# Important Information

## P89 Air Disc Brake

### ABS Sensor Block For P89 Integral and P89 Plus

February, 2018

Figure 1

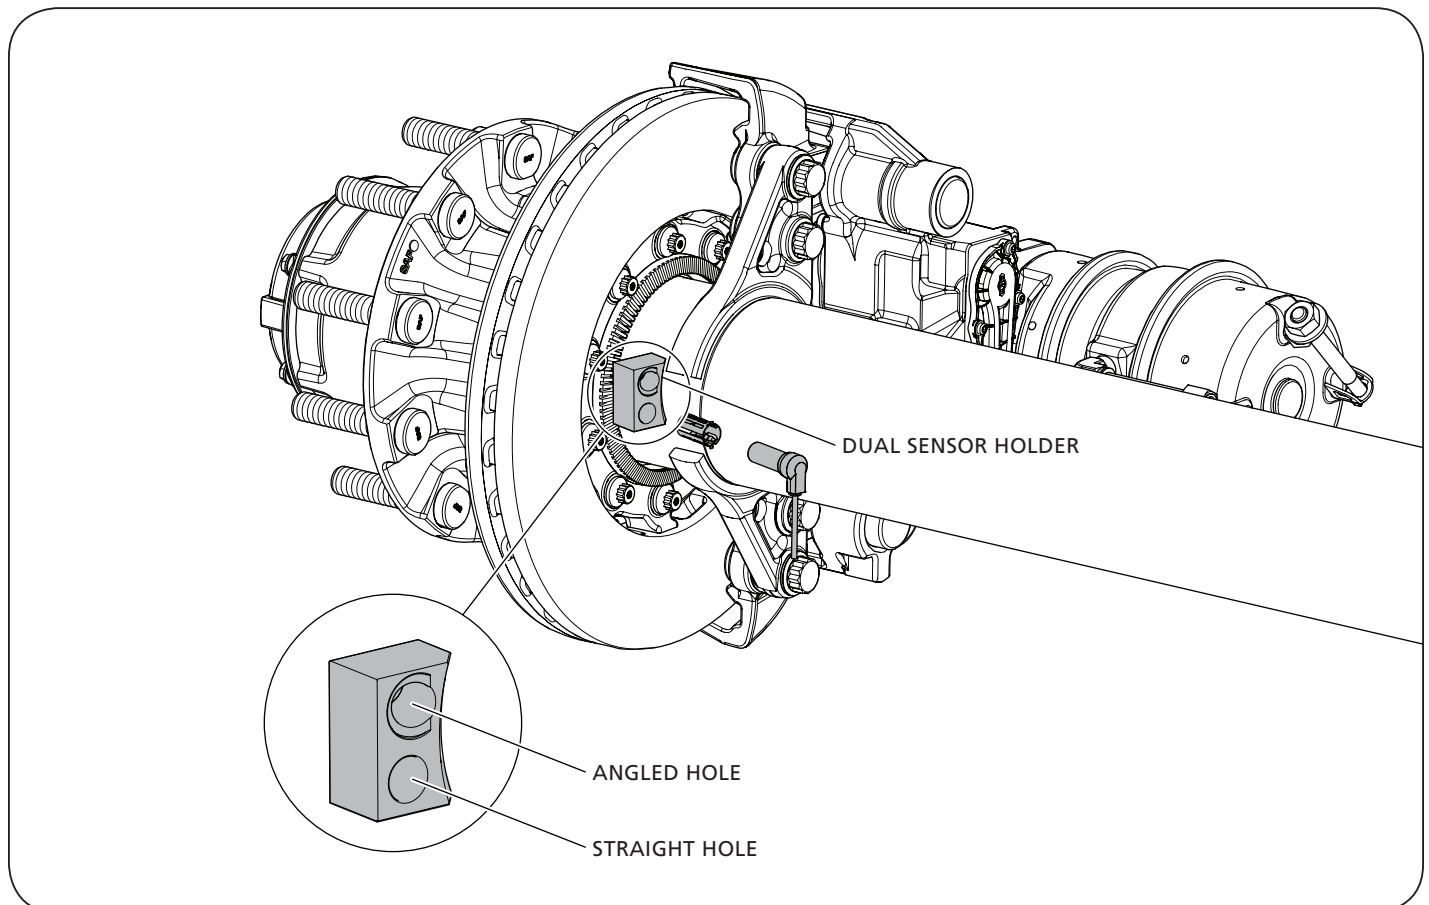
Beginning with shipments in October 2017, SAF-HOLLAND® implemented a design change to the ABS sensor mounting block for P89 INTEGRAL® and P89 Plus air disc brake axles (except self-steering axles). (The new sensor block will have two (2) mounting positions to accommodate different rotor designs and ABS tone positions.)

Axles equipped with SAF-HOLLAND's P89 INTEGRAL and P89 Plus air disc brake systems will continue to utilize the angled ABS mounting hole.

**NOTE:** For P89 Integral and P89 Plus a reverse sensor must use the angled hole. If reverse sensor and ABS sensors are required on the same axle, an additional mounting block is required. Please refer to reverse sensor manufacturer's installation instructions.
